In response to your request, LSC Transportation Consultants, Inc. has completed a traffic impact analysis for the proposed Harmony Phase 4 development. The site is located south of E. Alameda Avenue and east of Powhatan Road.

Comments: 01/29/2021

By: Kyle Morris (BHI)

Summary of Comments on TIS_rev1 redlines LSC Reponse.pdf

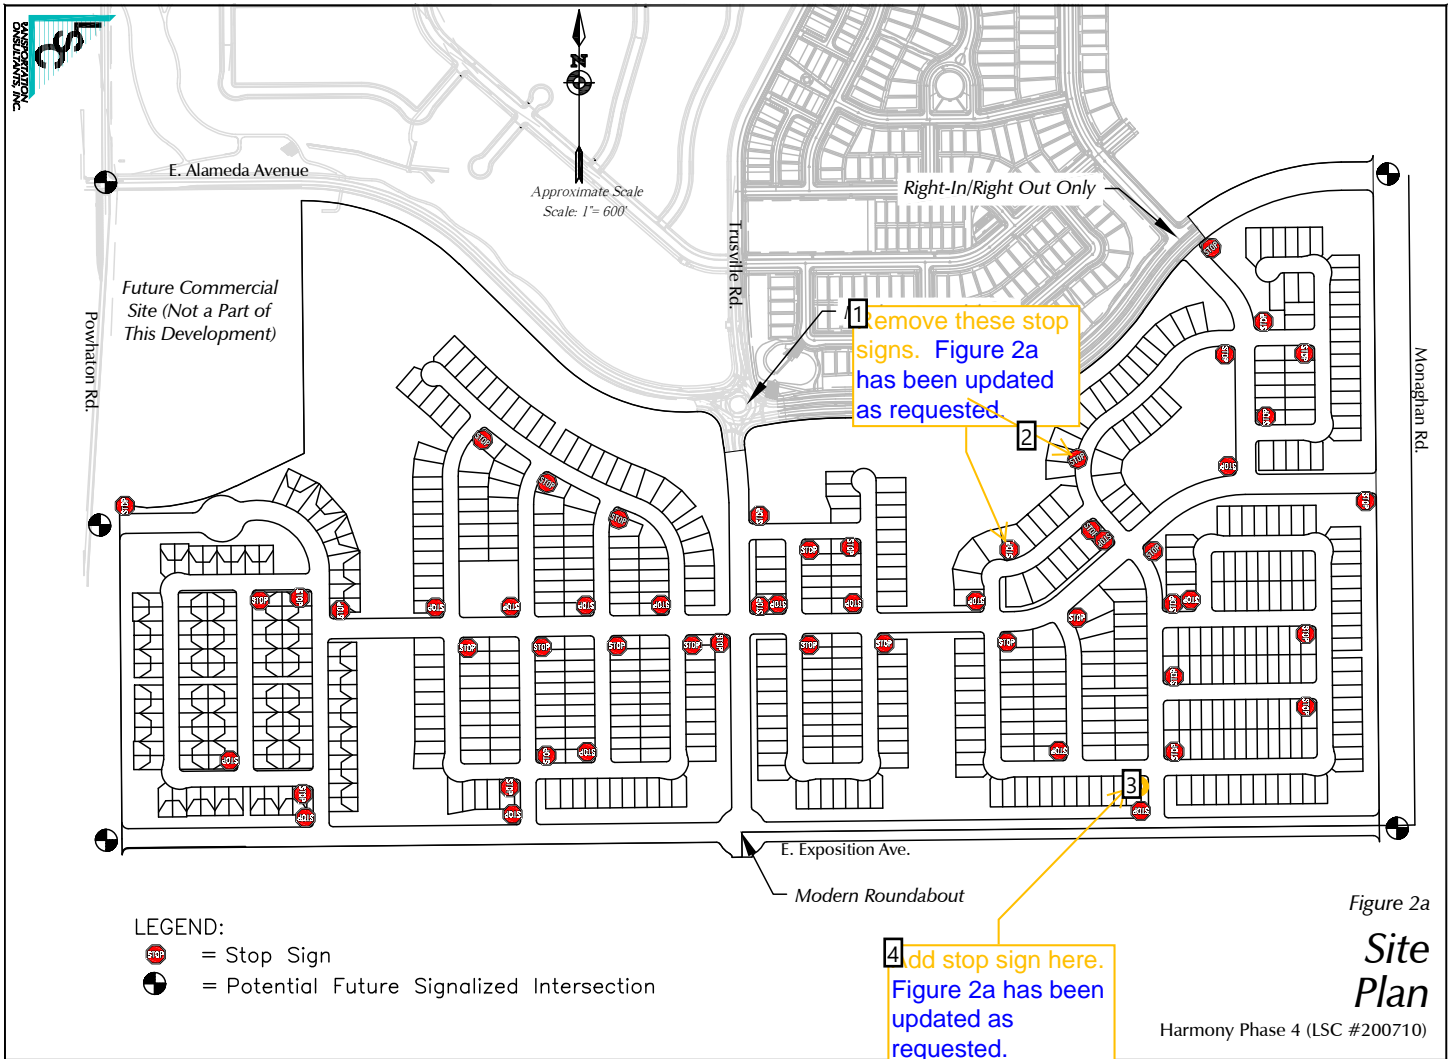
Comment on the minor street movement's ability to access and alternative route. The additional information has been added as requested.

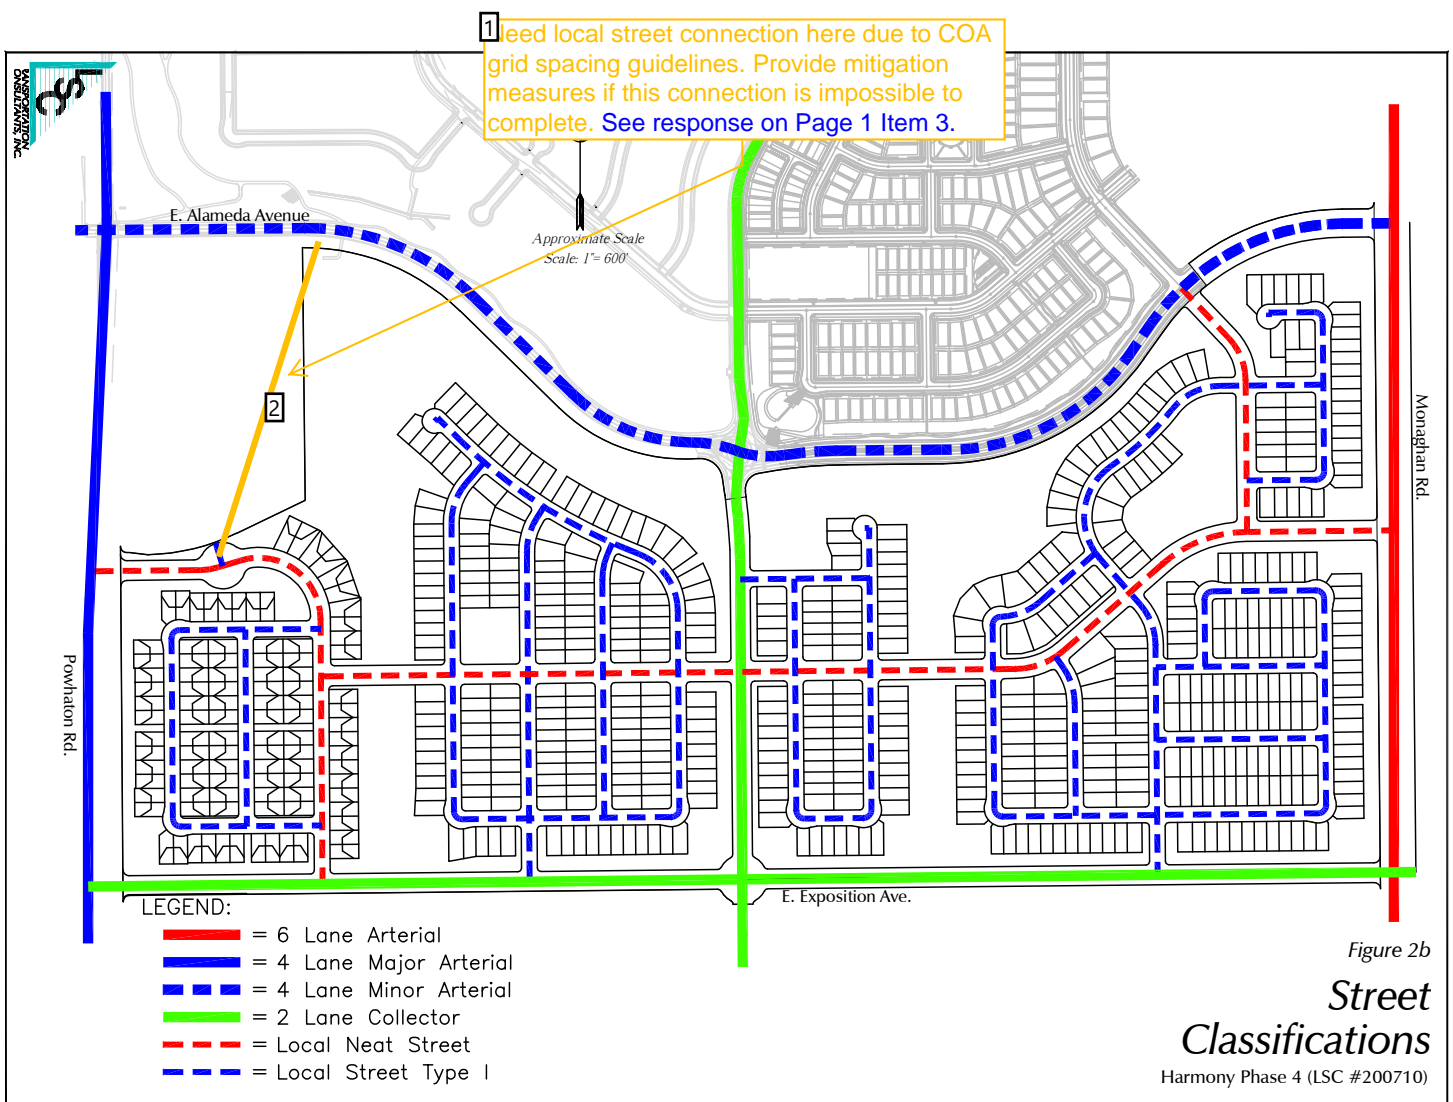
Remove these stop signs. Figure 2a has been updated as requested.

Add stop sign here. Figure 2a has been updated as requested.

Figure 2b

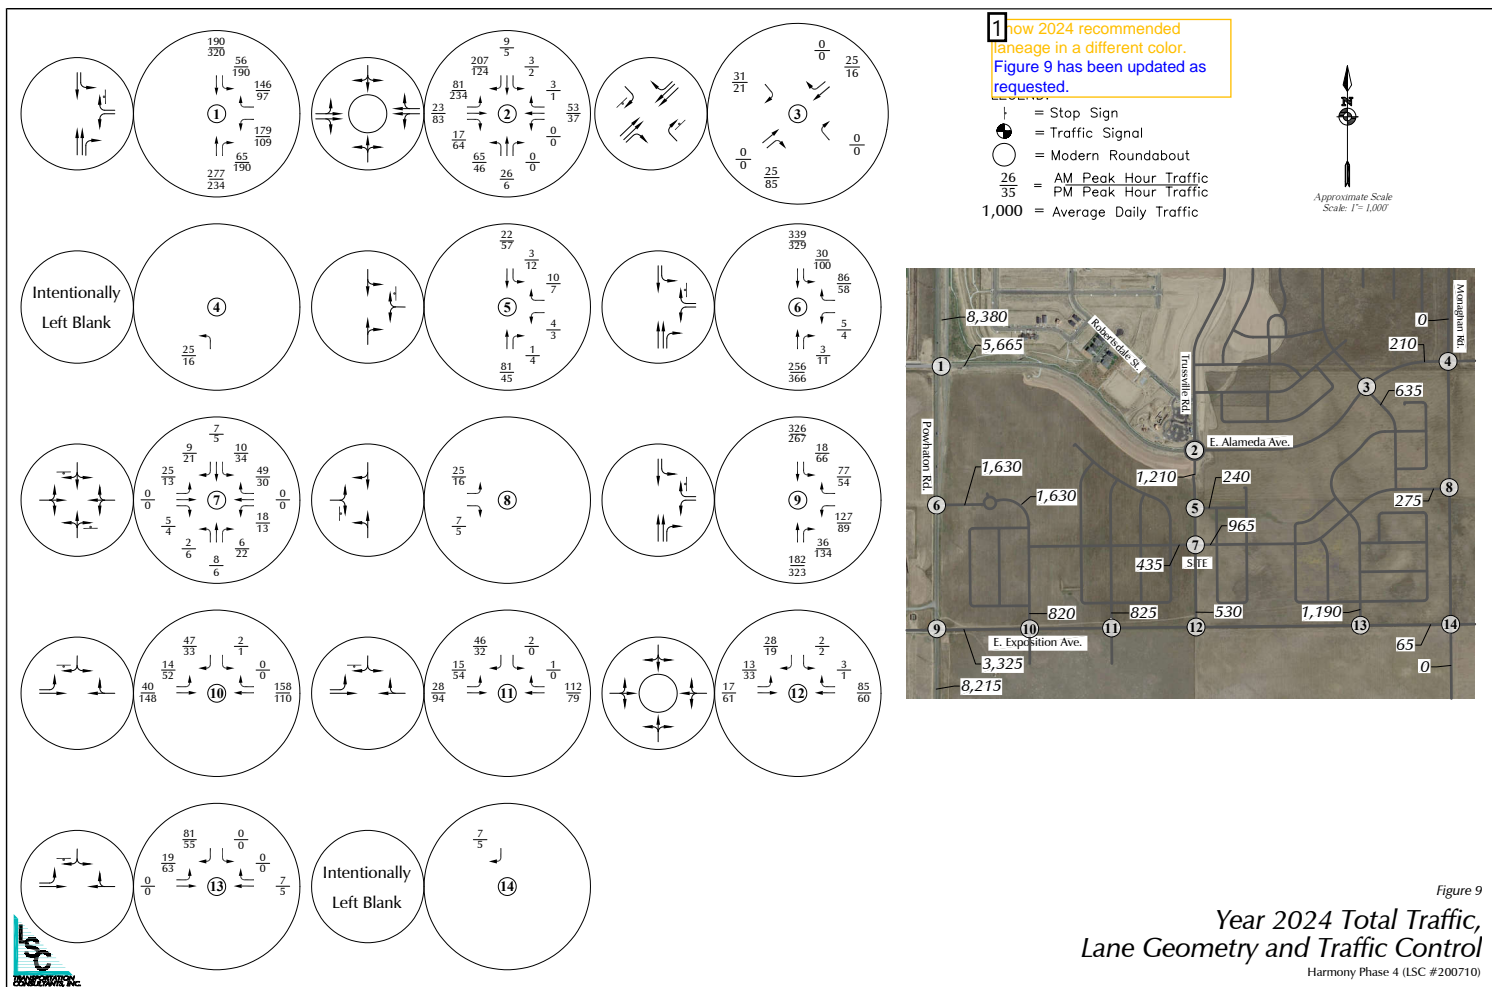
Need local street connection here due to COA grid spacing guidelines. Provide mitigation measures if this connection is impossible to complete. [See response on Page 1 Item 3.](#)
